**STAFF REPORT
KETCHUM PLANNING AND ZONING COMMISSION
MEETING OF SEPTEMBER 9, 2019**

PROJECT: Chess Lot Line Shift

FILE NUMBER: P19-078

REQUEST: Lot Line Shift to combine two lots of record

KETCHUM TOWNSITE: BLOCK 90, LOT 2A

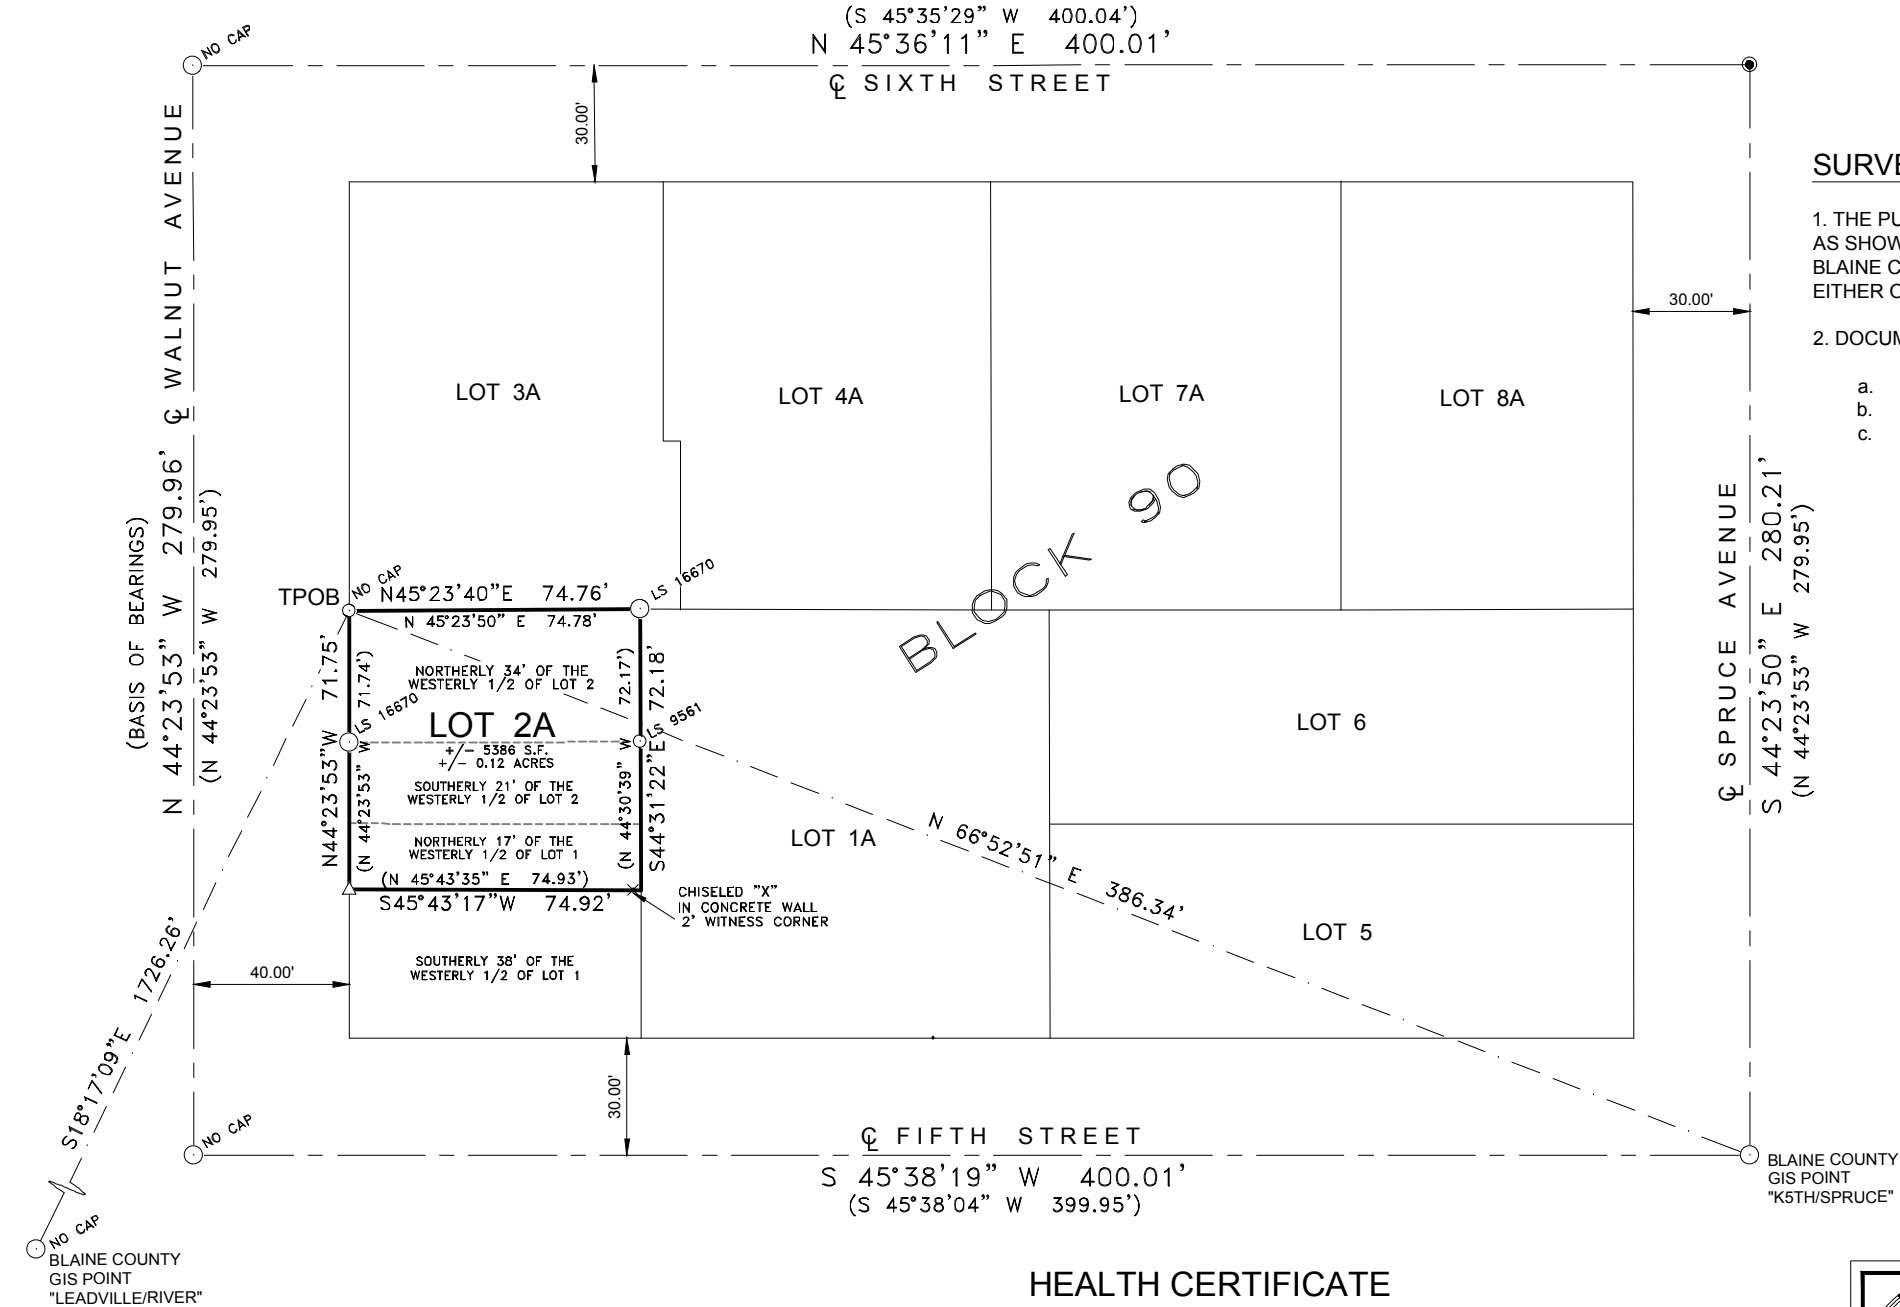
Staff notes three recommend conditions of approval pertaining to minor items not indicated on the plat: topographical contours, location of the two existing buildings, and the zoning designation. Staff recommends as a condition of approval that Benchmark Associates submit an exhibit indicating contours, the location of the existing buildings, and zoning designation, for the city's records prior to recording the plat. Benchmark Associates is aware of these conditions and intends to submit the exhibit.

<i>Staff Comments</i>	<i>Benchmark Associates will submit an exhibit indicating contours prior to the plat being recorded. See condition of approval #1.</i>

<input type="checkbox"/>	<input type="checkbox"/>	<input checked="" type="checkbox"/>	16.04.030.I.7	The scaled location of existing buildings, water bodies and courses and location of the adjoining or immediately adjacent dedicated streets, roadways and easements, public and private.
			Staff Comments	<i>Benchmark Associates will submit an exhibit indicating the location of the existing buildings prior to the final plat being recorded. See condition of approval #2.</i>
<input checked="" type="checkbox"/>	<input type="checkbox"/>	<input type="checkbox"/>	16.04.030.I.8	Boundary description and the area of the tract.
			Staff Comments	<i>The legal description appears on the proposed Preliminary Plat.</i>
<input type="checkbox"/>	<input type="checkbox"/>	<input checked="" type="checkbox"/>	16.04.030.I.9	Existing zoning of the tract.
			Staff Comments	<i>Zoning will be added to a supplemental exhibit prior to recording the final plat. See condition #3.</i>

1. Benchmark Associates shall submit an exhibit indicating topography contours prior to recording the final plat.
2. Benchmark Associates shall submit an exhibit indicating the location of the existing buildings prior to recording the final plat.

3. Benchmark Associates shall submit an exhibit indicating the existing zoning designation, LR, prior to recording the final plat.
4. The recorded plat shall show a minimum of two Blaine County Survey Control Monuments with ties to the property and an inverse between the two monuments. The Survey Control Monuments shall be clearly identified on the face of the map;
